UNITED STATES PATENT AND TRADEMARK OFFICE

| APPLICATION NO. | FILING DATE | FIRST NAMED INVENTOR | ATTORNEY DOCKET NO. | CONFIRMATION NO. |
|-----------------|-------------|----------------------|---------------------|------------------|
| 09/710,362 | 11/10/2000 | John C. Connolly | PLW 13206 | 5398 |

Office Action Summary

DETAILED ACTION

FIG. 13

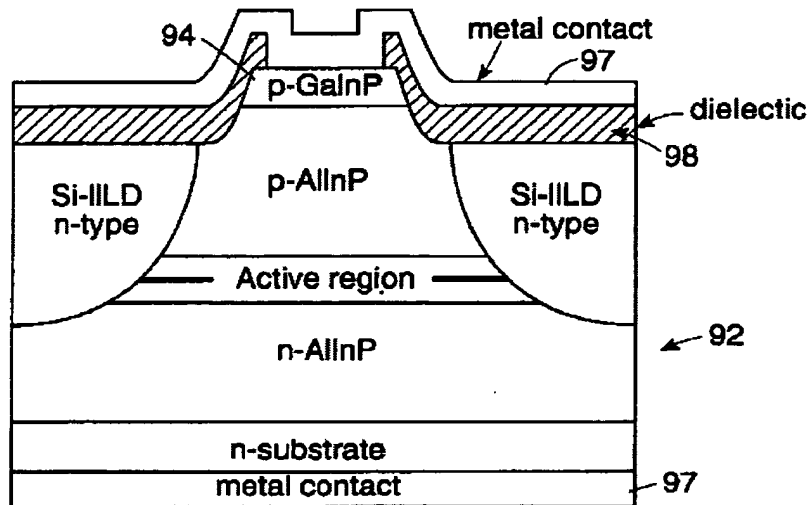
Regarding claim 24, Beernink discloses, especially in Figs. 11-13 and the discussion thereof on col. 8, a buried ridge waveguide semiconductor laser diode comprising a first cladding layer 95 having a ridge with a first width at the bottom of the ridge, a second cladding layer, an active layer disposed between the first and second cladding layers, a first conductor layer 97 disposed on top of the ridge, and a second conductor (also 97) for conducting current through the active layer. The active layer has a defined gain region (the part marked "Active region") that conducts the current and has a width greater than the width of the bottom of the ridge. There are reduced conductivity regions within the active layer and flanking the defined gain region.

Beernick discloses that the laser device is a buried ridge type laser. It is not disclosed that the laser should be a ridge waveguide laser. However it is well known that in many applications a ridge waveguide laser and a buried heterostructure laser may be interchangeable. See any of the references cited in this action but not relied upon as evidence of this statement of Official Notice. In these references, it is commonly asserted that for the given invention, embodiments may be made in either of these forms, or it is asserted that either type of laser structure is well known in the art and may be used. Thus, the Examiner contends that the present invention requiring a ridge waveguide type laser does not distinguish over Beernick. Since it has been shown that it is well known that either structure may be used, then an embodiment of Beernick where the laser structure is a ridge-waveguide type would have been an obvious variant of the buried heterostructure laser of Beernick. Further, Sun provides evidence that ridge waveguide type lasers may be advantageous over buried heterostructure lasers (col. 6 lines 24-37). It would thus have been obvious to one skilled in the art, not only that buried heterostructure and ridge

waveguide type lasers may be interchangeably used, but that a ridge waveguide type would be advantageous and thus such a structure should be used in Beernick, because this will lead to improved fabrication thus improving yield, as taught by Sun.
